**TOWN OF MOUNTAIN VILLAGE  
DESIGN REVIEW BOARD REGULAR MEETING  
THURSDAY DECEMBER 1, 2016 10:00 AM  
2nd FLOOR CONFERENCE ROOM, MOUNTAIN VILLAGE TOWN HALL  
455 MOUNTAIN VILLAGE BLVD, MOUNTAIN VILLAGE, COLORADO  
REVISED AGENDA**

4.	10:10	45	Bangert	Work Session	Conceptual Work Session application for a new single family home on Lot 233A, 103 Gold Hill Court,
5.	10:55	30	Van Nimwegen	Worksession	Continue review of the Design Regulations of the Community Development Code.

**Application Overview:** The purpose of this agenda item is to allow the Design Review Board (DRB) to provide initial direction to the applicant regarding a proposed new single family home.

## A2.1 site plan

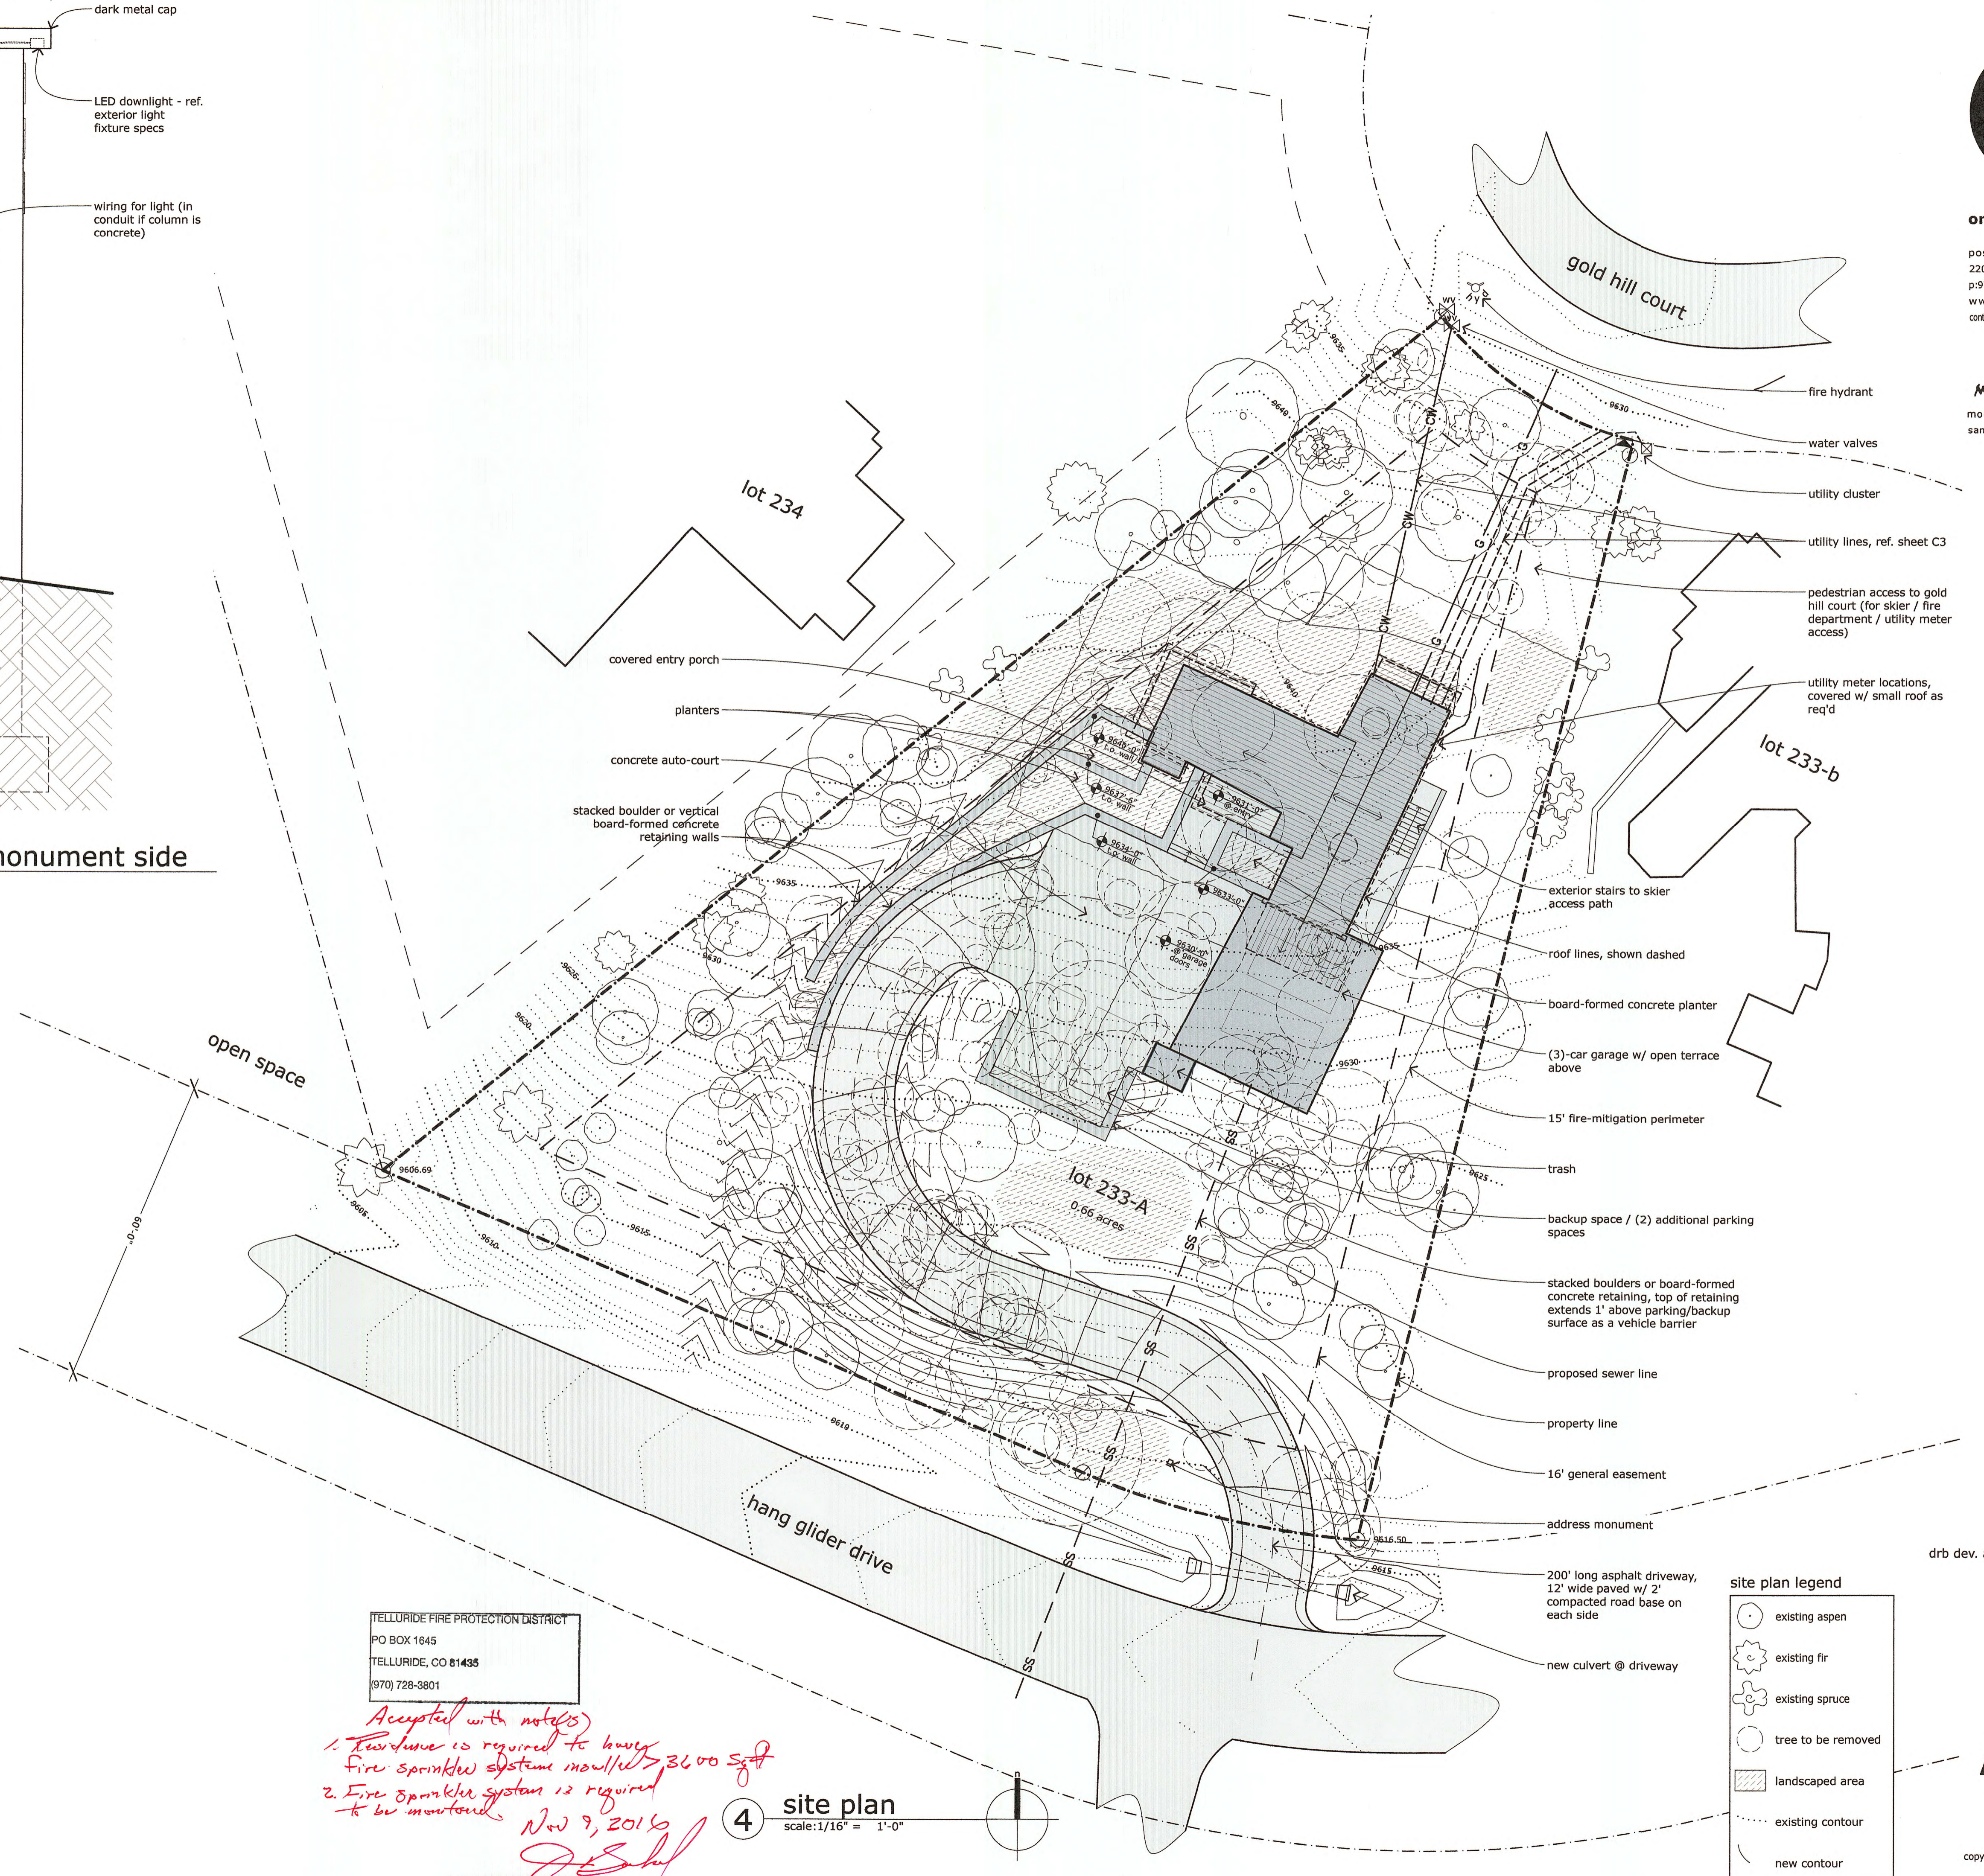
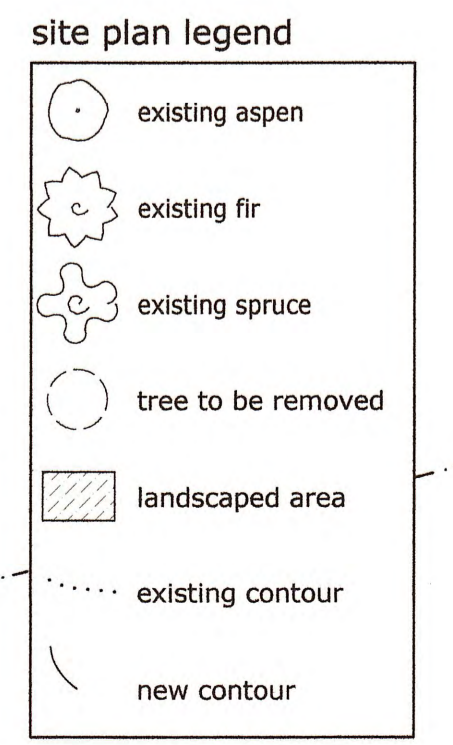
The proposed driveway grades will require specific approval from the DRB. The first 20' of the drive is shown at 5.4% which is over the 5% maximum for the first 20' and the transition section between the curves is shown at 9.7% which is over the 8% maximum grade. The Telluride Fire Protection District has approved the driveway plans as proposed. Public works has no problem with the 5.4% grade in the first 20' and is in favor of the driveway coming from Hanglider Dr. as opposed to the Gold Hill Ct. cul-de-sac

*Accepted with notes*  
 1. Fire insurance is required to lower  
 Fire sprinkler system manifold > 3600 sqft  
 2. Fire sprinkler system is required  
 to be monitored  
 Nov 9, 2016  
*[Signature]*
